PG&E Letter DCL-03-047

Docket No. 50-275, OL-DPR-80
Docket No. 50-323, OL-DPR-82
Diablo Canyon Units 1 and 2
Response to NRC Request for Additional Information Regarding License Amendment Request 02-03, "Spent Fuel Cask Handling"

PG&E Response to NRC Request for Additional Information Regarding License Amendment Request 02-03, "Spent Fuel Cask Handling"

FIGURE 5.1-1 (1 of 3)
OPERATION SEQUENCE FLOWCHART FOR CASK SYSTEM LOADING, SEALING, TESTING, AND STORAGE

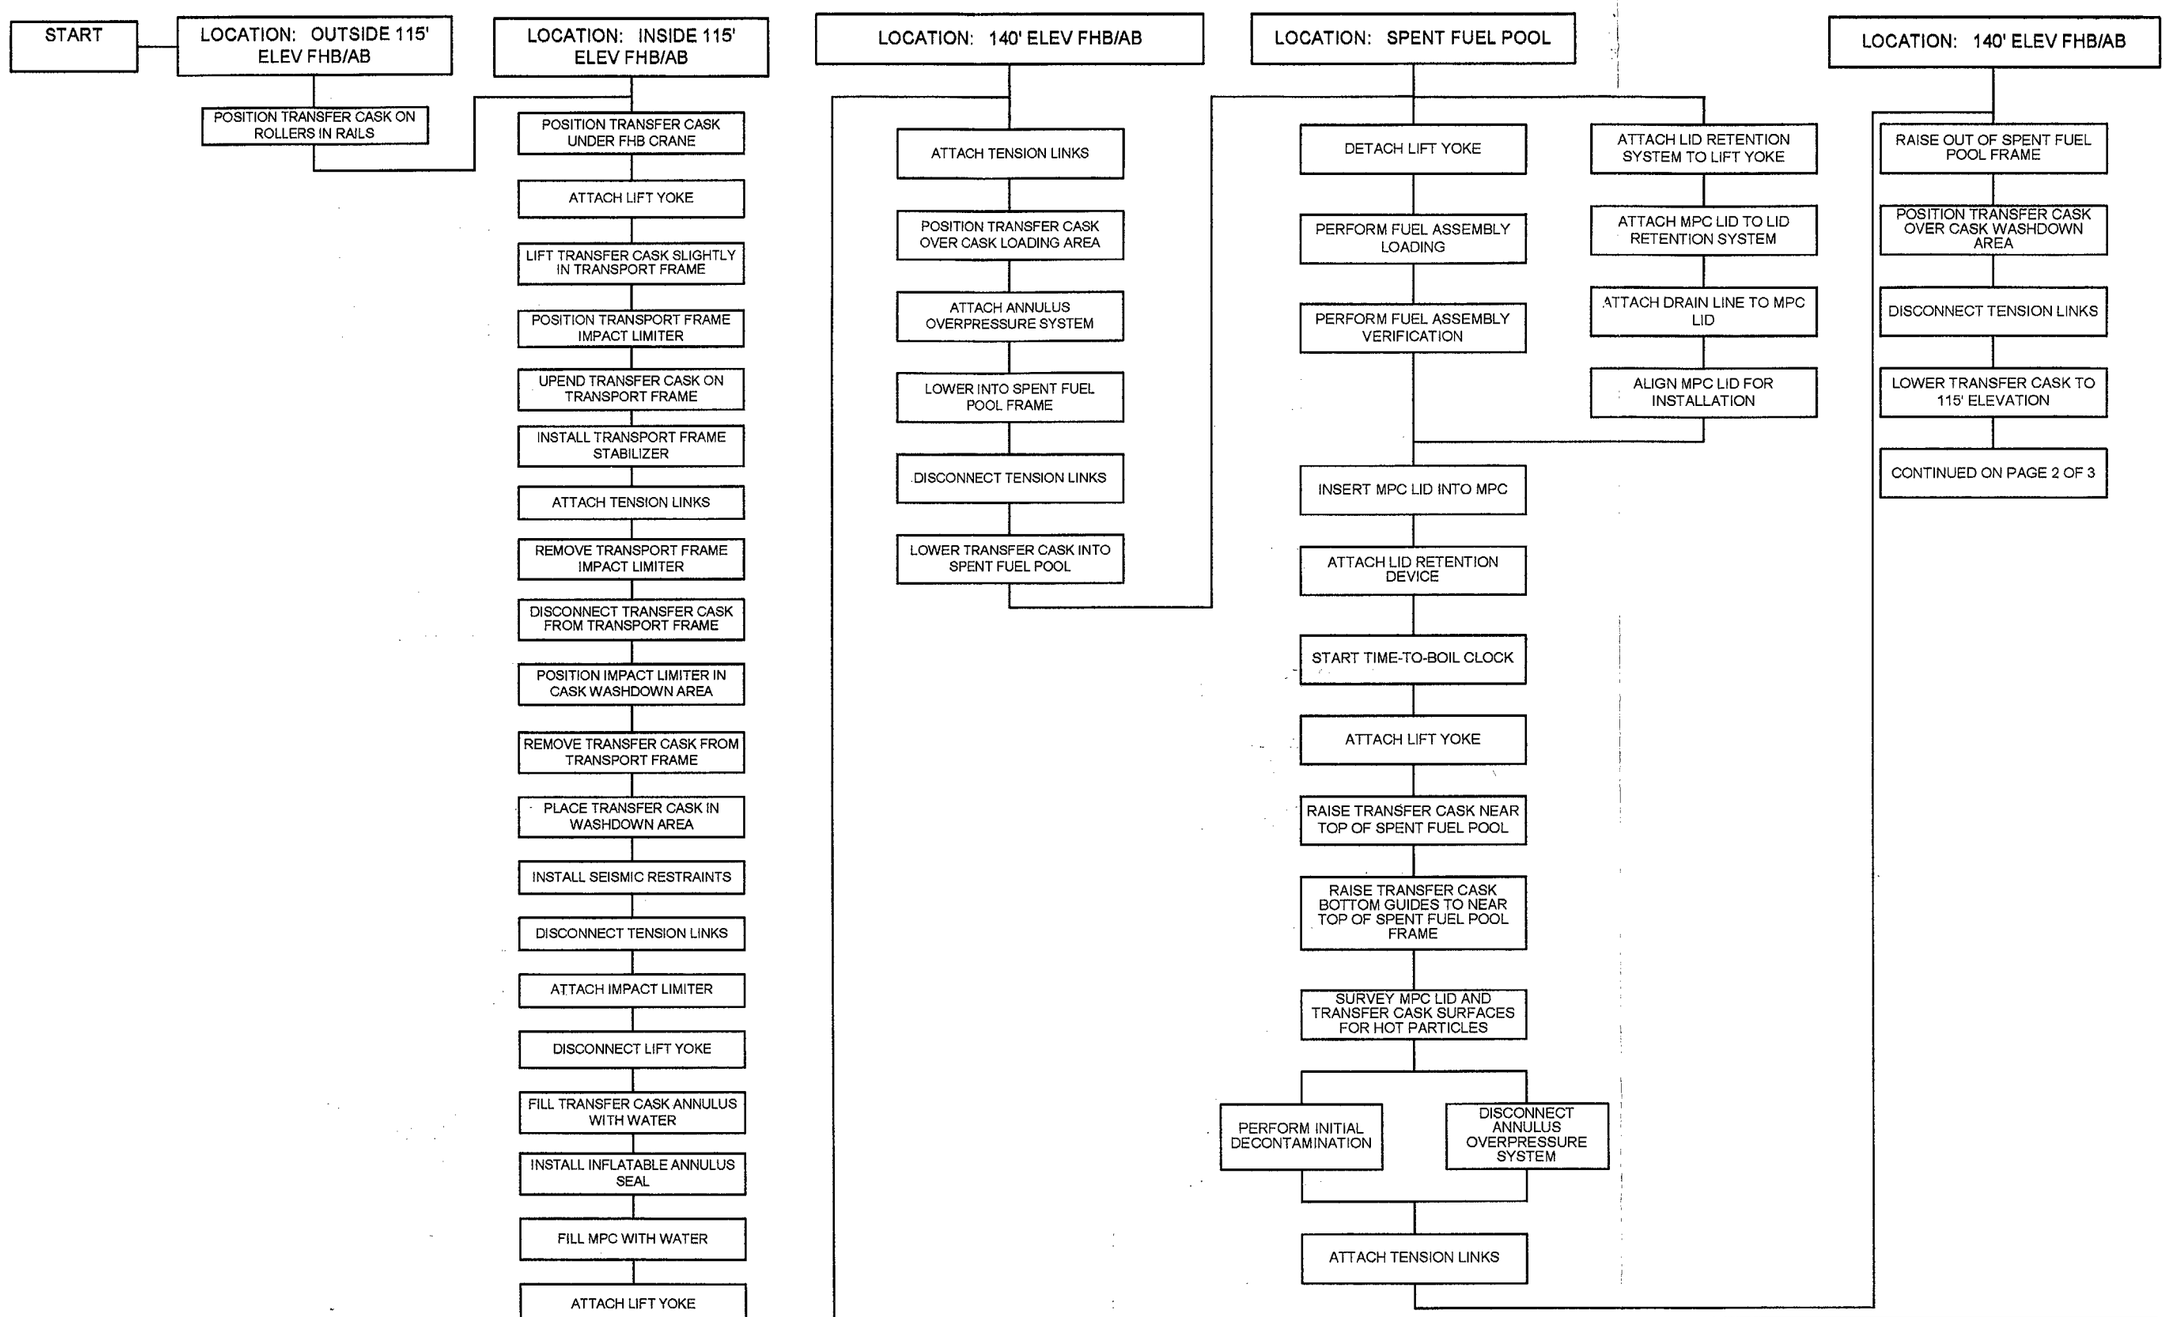
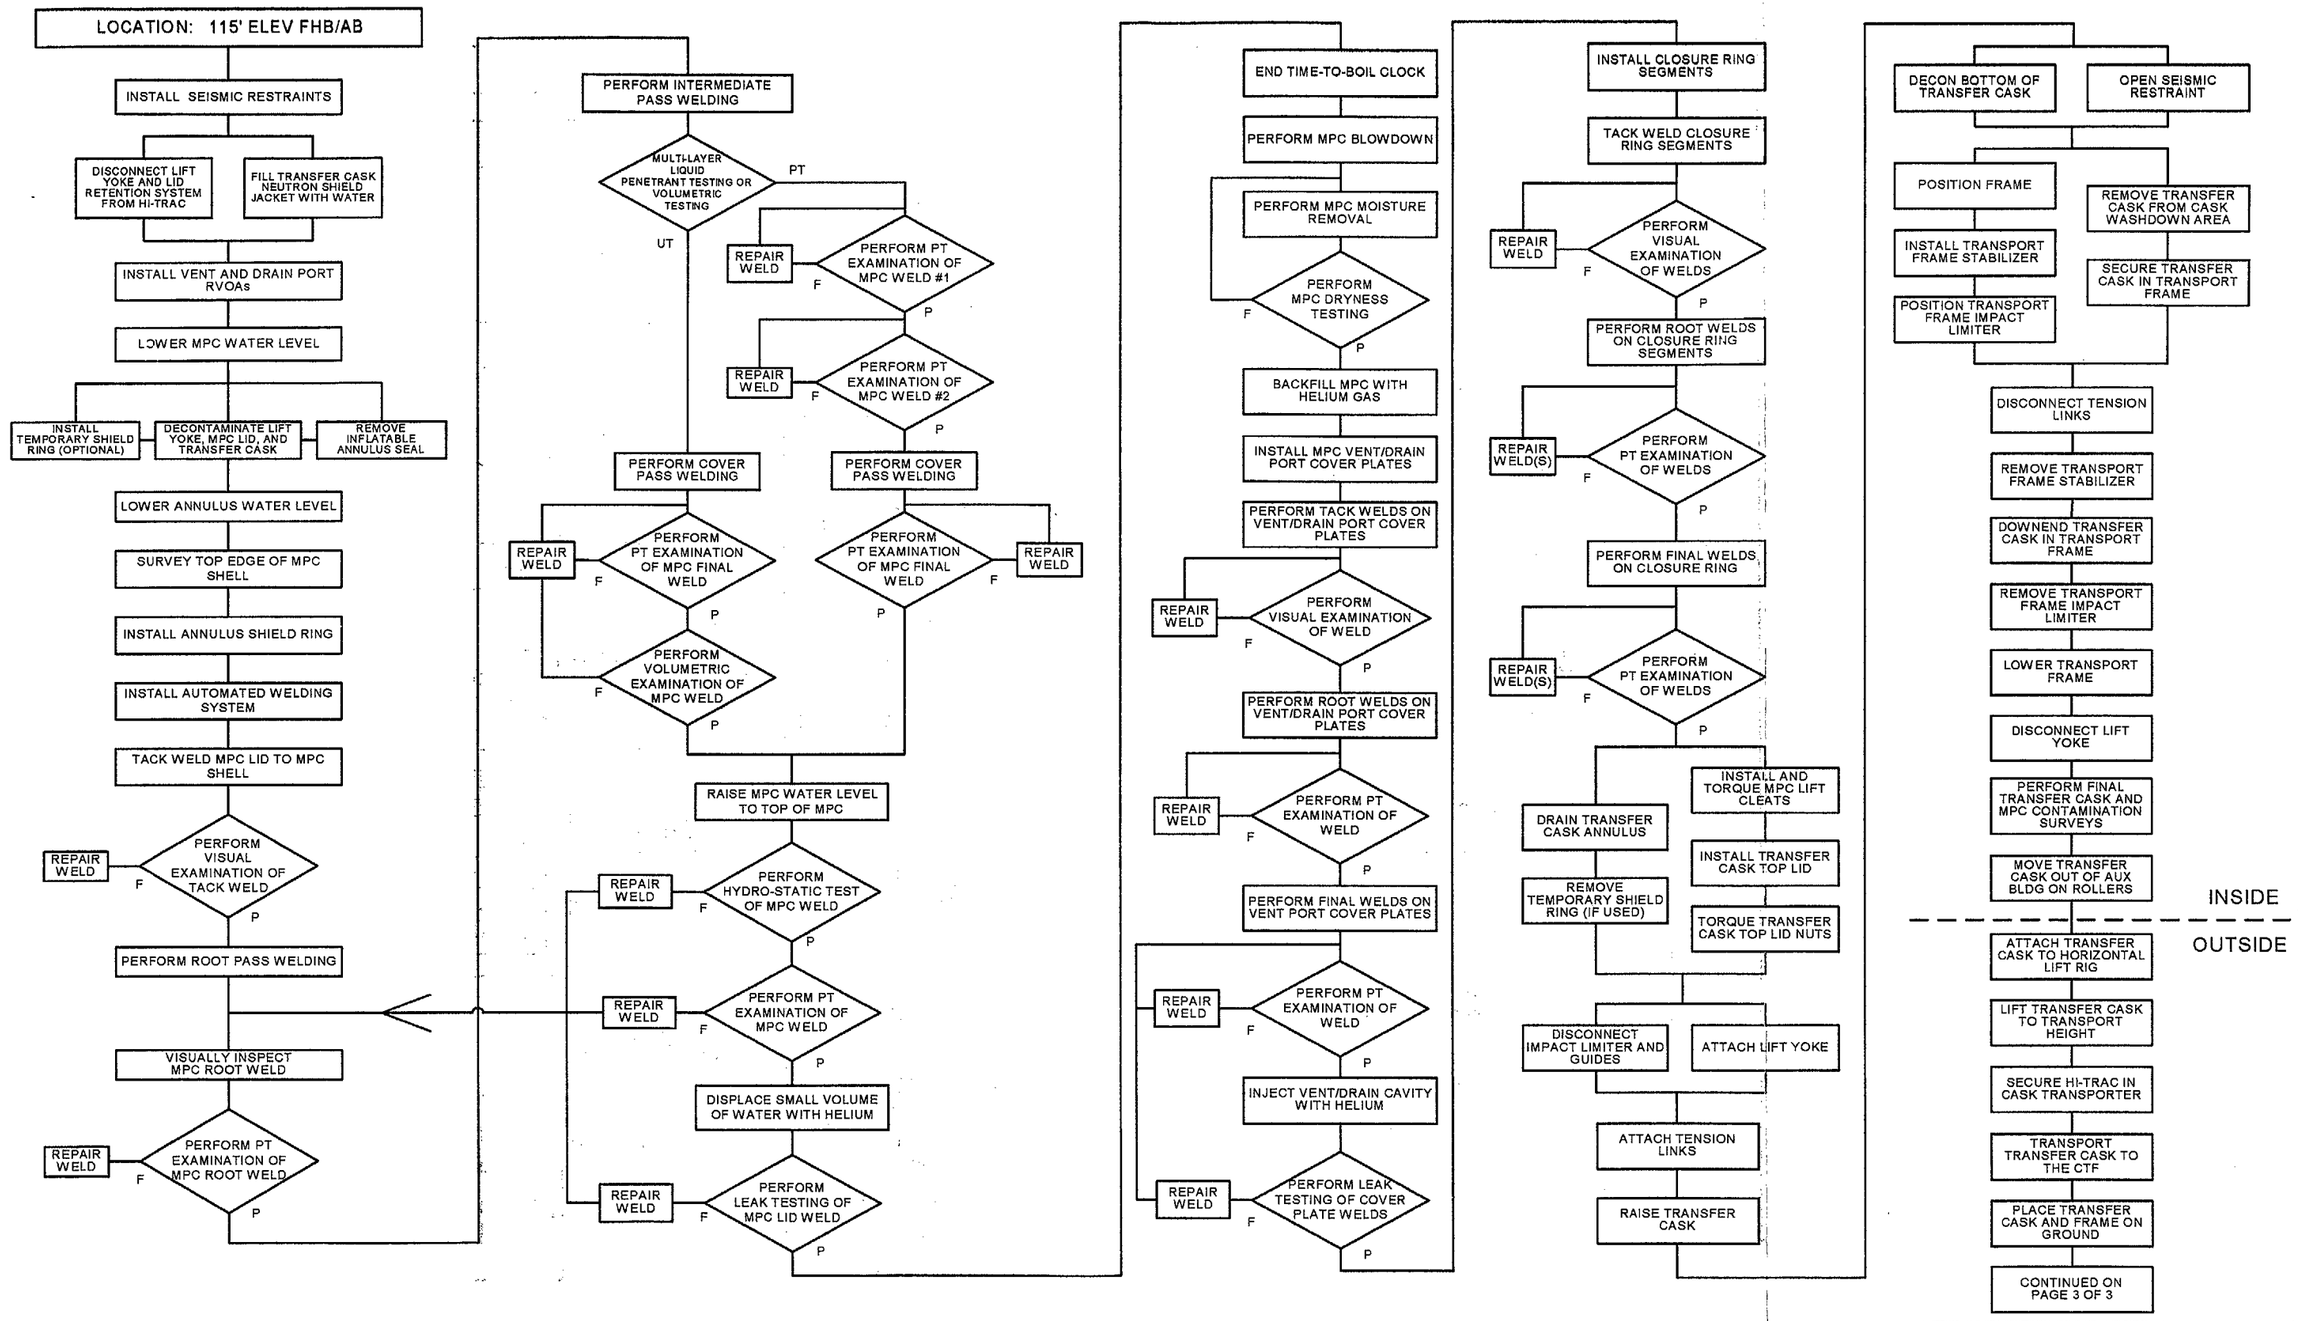
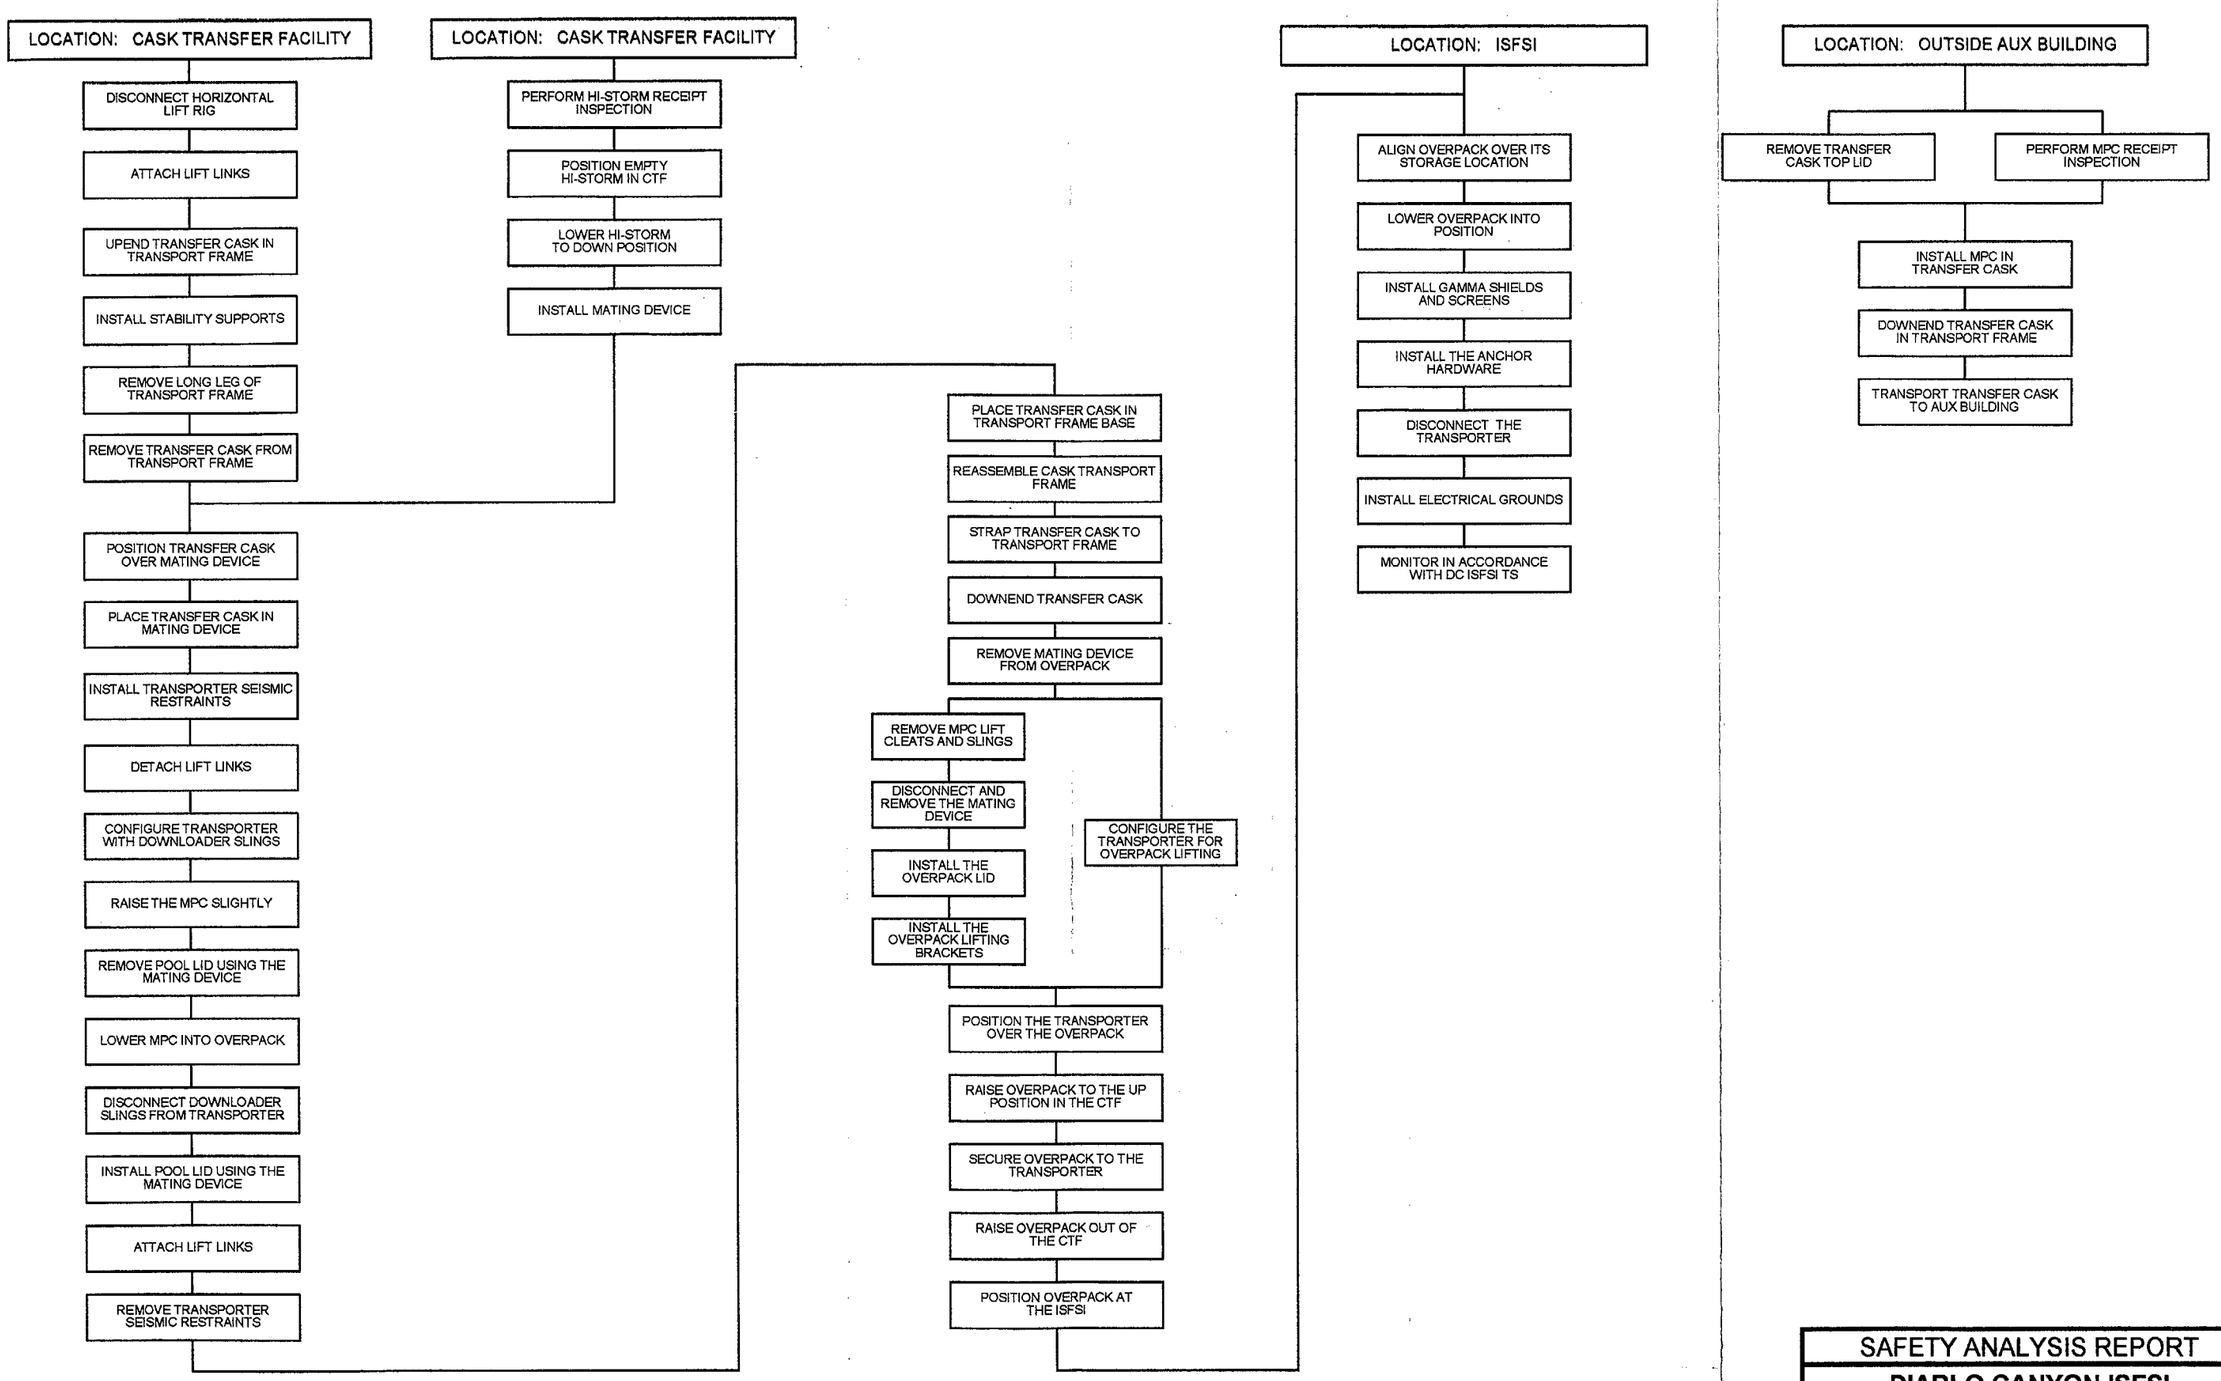
The Diablo Canyon Power Plant (DCPP) license amendment request to revise the DCPP updated final safety analysis report (UFSAR) regarding its control of heavy loads program proposes to eliminate the spent fuel cask exclusion zone. The UFSAR restricts cask movement to the portion of the spent fuel pool which is over the cask recess area. The defense-in-depth approach within NUREG-0612, "Control of Heavy Loads at Nuclear Power Plants," states that despite the increase reliability of the overhead handling system licensees should (1) provide sufficient operator training, handling system design, load handling instructions, and equipment inspection to assure

reliable operation of the handling system; and (2) define safe load paths through procedures and operator training so that to the extent practical heavy loads avoid being carried over or near irradiated fuel or safe shutdown equipment. Provide your basis for eliminating the cask exclusion area? Demonstrate how the defense-in-depth philosophy described will be maintained through your cask handling operations supporting your proposed independent spent fuel storage installation (ISFSI).

An operational sequence depicting the cask handling operations is presented in the enclosed Diablo Canyon ISFSI SAR Figure 5.1-1, which was previously submitted in PG&E Letter DIL-01-002 dated December 21, 2001 under Docket No. 72.26. Using LAR Figures 8 and 9 along with the sequence presented, provides a "pool to pad" map of cask handling operations.
